P 529589
 A 526625

ON-SITE SEWAGE DISPOSAL SYSTEM HOWARD COUNTY HEALTH DEPARTMENT BUREAU OF ENVIRONMENTAL HEALTH

ADDRESS: 2732 McKendree Road PROPERTY OWNER: Brigitte L. Droegemeyer
~~William E. and WF Teal~~
rcb 10/16/08

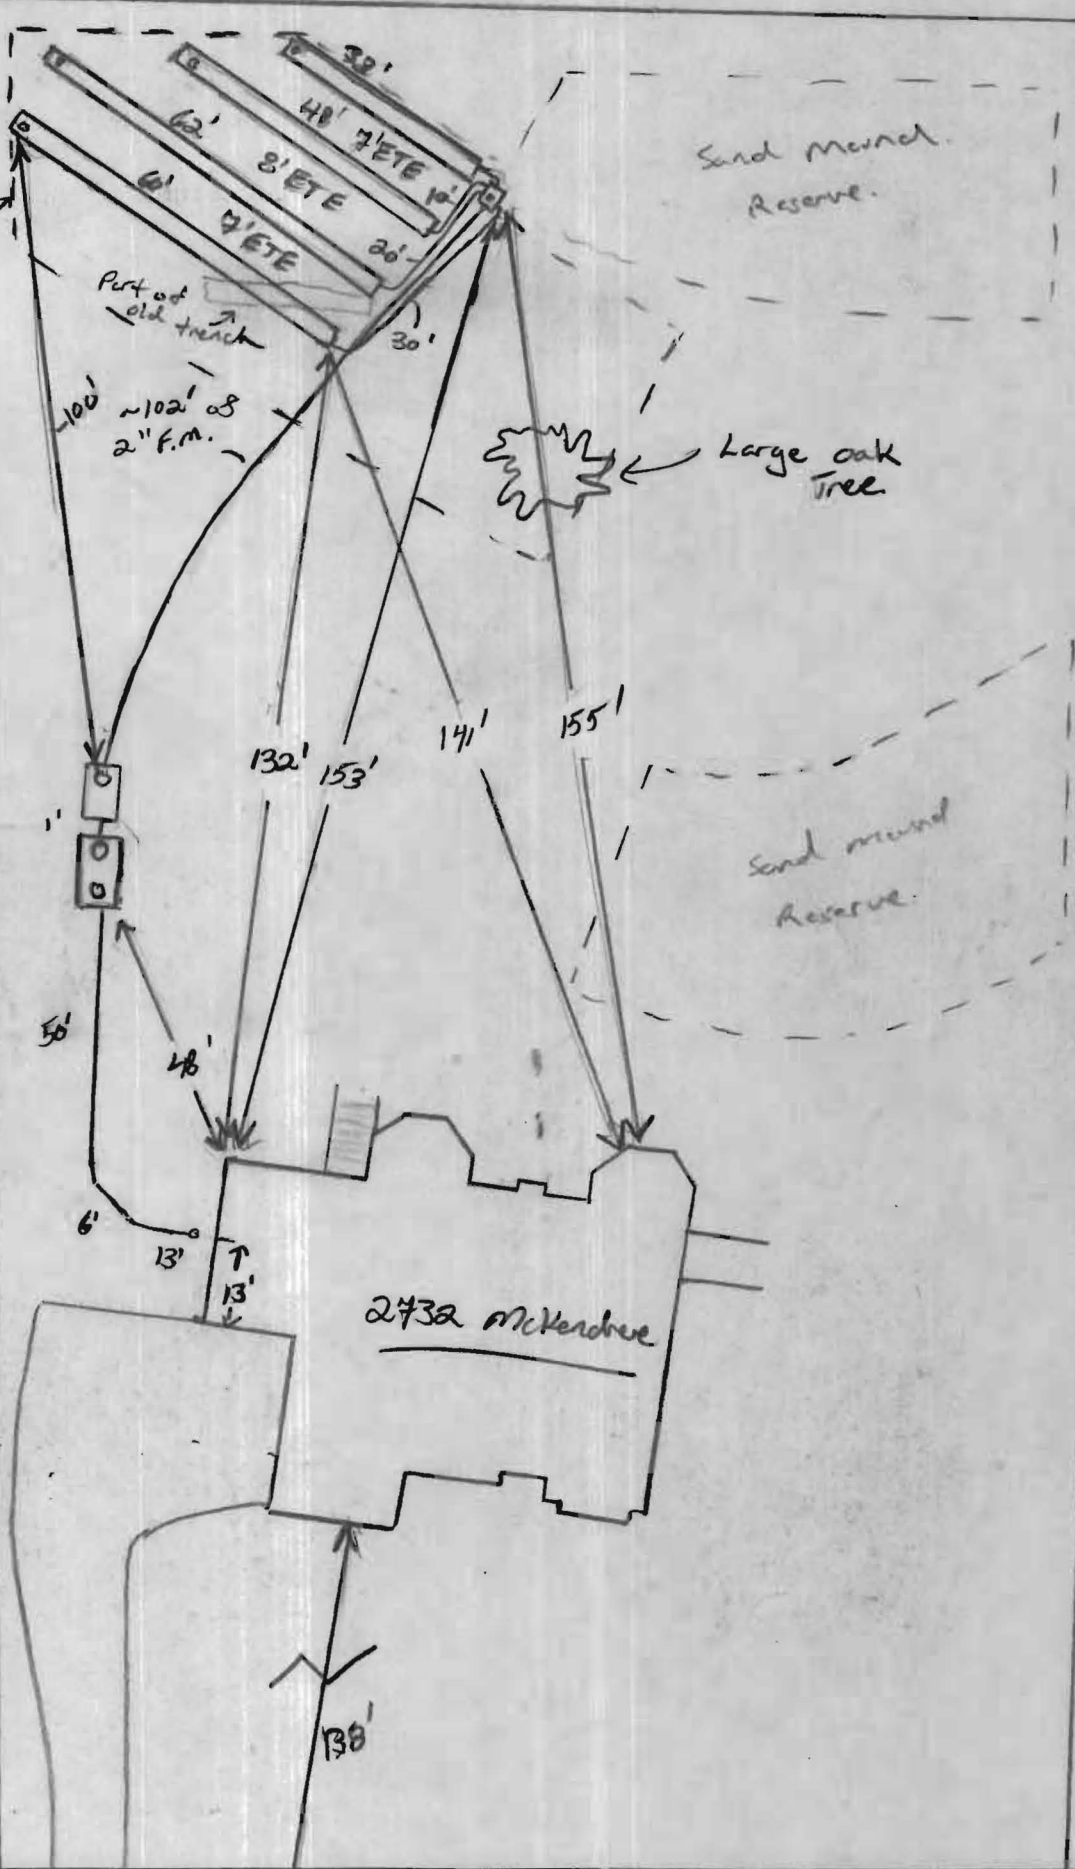
F.M. installed along w/ 4" SHC. No house connection made. Noticed septic area was not staked according to 5' variance approval to property line (pulled off 3 of 4 prop corners and triangulation of house loc). Told contractor to dig last trench 5' over towards prop line. He already had 50' of the trench dug. Hit into ex. old trench. Told contractor to dig 5' out and fill w/ clay material. (KW)

10/31/08 Inlet 2.5. Bottom 6'. Trenches 3' wide. Move tanks uphill to keep out

of water table and increase soil weight / depth on top of them. Two thousand gallon tank needs 3' of cover. If pump tank depth is greater than 4' a traffic bearing lid is required. Use bentonite to seal tanks. Install system as per layout and there should be enough room for a repair. (PB 10/3/08) Tanks moved out of water further uphill. Tanks arriving. Looks OK. Call for S/V inspection (KW)

No one working. Contractor has tanks set w/ Risers, sealed w/ bentonite. Top 3 trenches installed. Some septic area staked missing. Will follow up tomorrow. (KW)

5' variance

LOCATION DRAWING
2732 MCKENDREE ROAD
PARCEL 44
FOURTH ELECTION DISTRICT
HOWARD COUNTY, MARYLAND

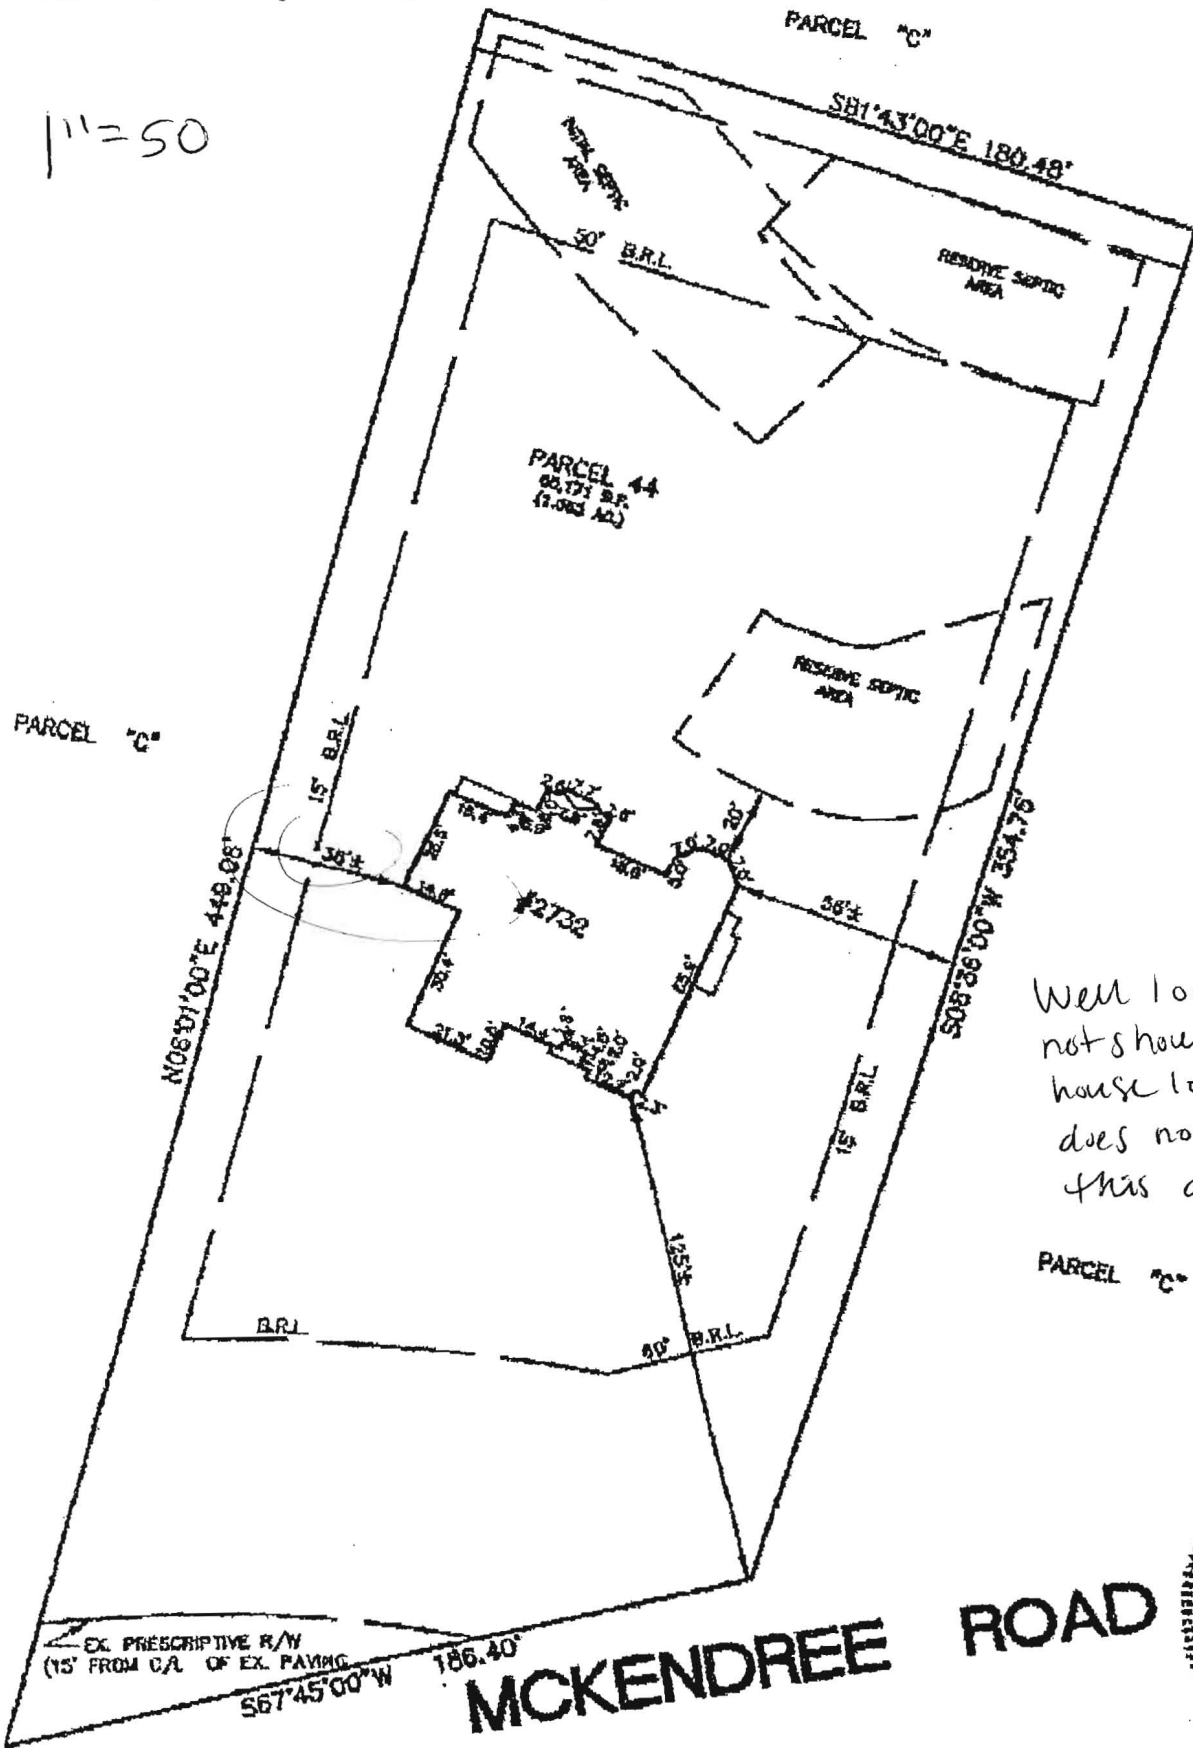
Well location not shown but house location does not affect this area
